Access Compliance Report

Public Rights-of-Way

(Curb Ramps)

Intersection ID: 15763	Main Street: MONROE_RD	Cross Street: N_WENDOVER_RD	Location: SE
ADA ID: 8D7EEDEE5940	Ramp Type: Perp	Initial Pass/Fail: Fail	Overall Compliance: No
Severity Score: 12.5			
Codes/Mitigation Info/Possible Solution		Field Measurements/Component Compliance

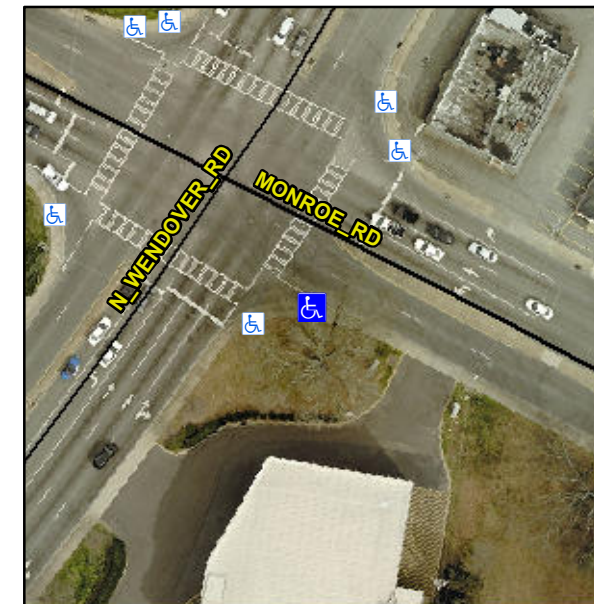
Not Found, R304.2.2

Compliance	Description	Data	Compliance	Description	Data
N/A	Ramp Length (in)	58.0	No	Ramp Slope (%)	10.6
Yes	Ramp Width (in)	49.0	Yes	Ramp XSlope (%)	0.2
N/A	Flare Type LT	N/A	N/A	Flare Type RT	N/A
N/A	Flare Slope LT (%)	N/A	N/A	Flare Slope RT (%)	N/A
N/A	Flare Traversable LT?	N/A	N/A	Flare Traversable RT?	N/A
N/A	Landing Length (in)	N/A	N/A	DWS Provided?	N/A
N/A	Landing Width (in)	N/A	N/A	DWS Contrast?	N/A
N/A	Landing Slope (%)	N/A	N/A	DWS Length (in)	N/A
N/A	Landing X Slope (%)	N/A	N/A	DWS Full Width?	N/A
N/A	Landing Curb? (Y/N)	N/A	N/A	DWS Offset (in)	N/A
N/A	Shared Landing?	N/A			
N/A	Gutter Ponding?	N/A	N/A	Gutter Slope (%)	N/A
N/A	Gutter Lip Ht (in)	N/A	N/A	Gutter X Slope (%)	N/A
N/A	Painted X Walk1?	No	N/A	Painted X Walk2?	N/A
	X Walk 1 Direction	To NE		X Walk 2 Direction	N/A
N/A	X Walk 1 Width (in)	N/A	N/A	X Walk 2 Width (in)	N/A
	X Walk 1 Slope (%)	0.3		X Walk 2 Slope (%)	N/A
	X Walk 1 X Slope (%)	0.3		X Walk 2 X Slope (%)	N/A

Remove & Replace Entire Ramp.
